SDG&E Comments on 2017-2018 CAISO Preliminary Study Results Reported in 9/2017 Stakeholder Meeting

10/6/2017

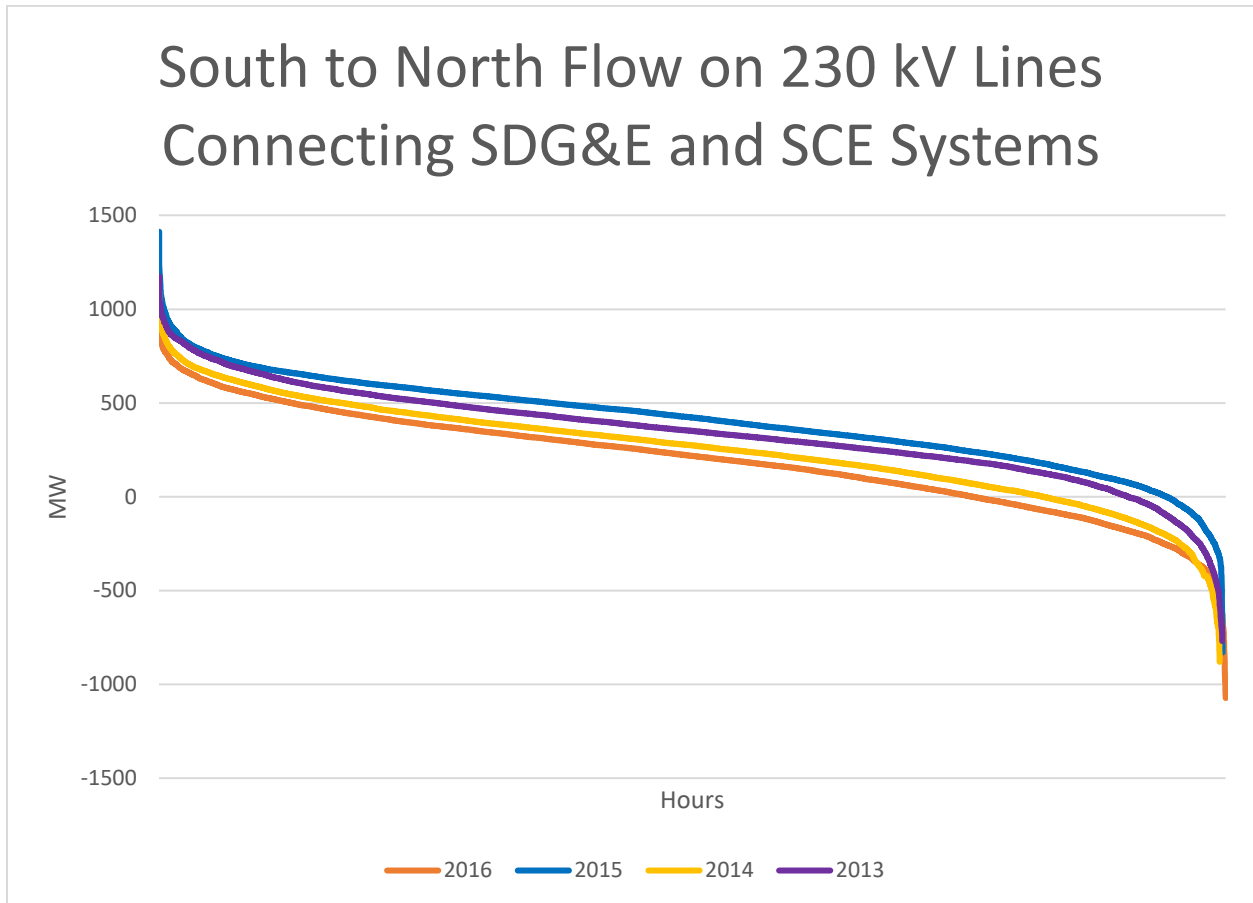
The change in flow patterns is also related to the San Onofre nuclear power plant shut down. Northbound flow from the SDG&E system into the SCE system is now normal, not just "occasional." The graph below shows for the years 2013, 2014, 2015, and 2016, the south-to-north flow on the 230 kV lines connecting the SDG&E and SCE transmission systems (retired Path 44).

- c In the higher northbound flow cases, overloads appear under many contingencies including P1. SDG&E is very concerned about the potential risk of reliability criterion violations for a significant number of hours in a year as shown in the duration curves.
